DEVELOPMENT REVIEW BOARD REPORT

87-DR-2004#3
Hayden Peak Crossing Pad E

Request approval for a site plan and elevations to add an 8,301 square-foot multi-tenant commercial building at Pad E of the Hayden Peak Crossing Shopping Center.

PAD E ELEVATIONS

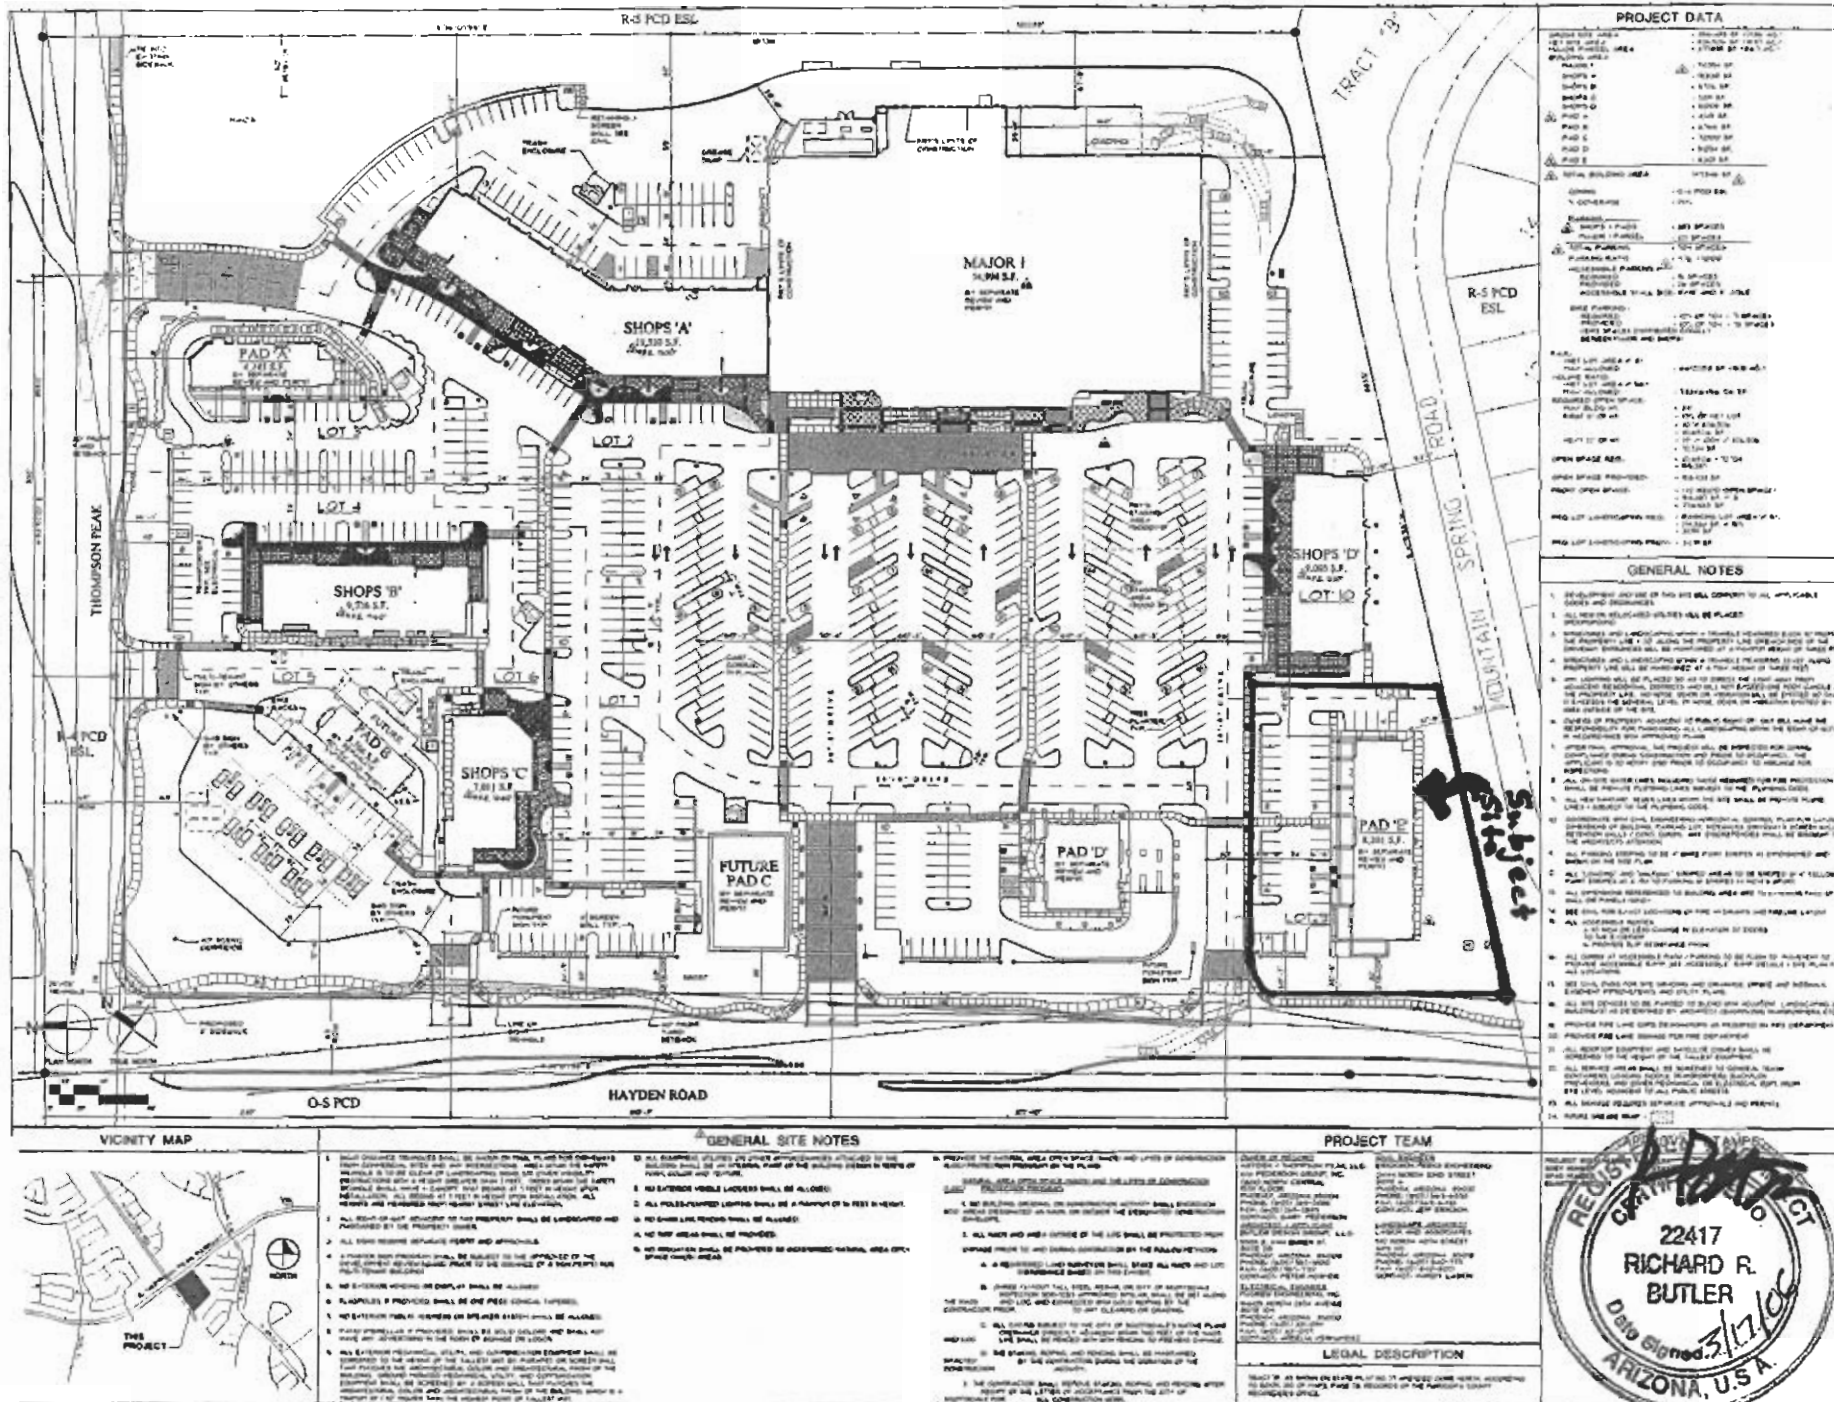
2. All window glazing shall be clear non-reflective.
3. The face of the service entrance section(s) shall be flush with the building façade and painted to match the building.

4. All exterior mechanical, utility, and communications equipment shall be screened by parapet or wall that matches the architectural color and finish of the building. Wall or parapet height for roof-mounted units shall meet or exceed the height of the tallest unit. Wall height for ground-mounted units shall be a minimum of 1 foot higher than the tallest unit.

7. Roof drainage systems shall be interior, except that overflow scuppers are permitted. If overflow scuppers are provided, they shall be integrated with the architectural design.

8. Wall enclosures for refuse bins or trash compactors shall be constructed of materials that are compatible with the building(s) on the site in terms of color and texture.
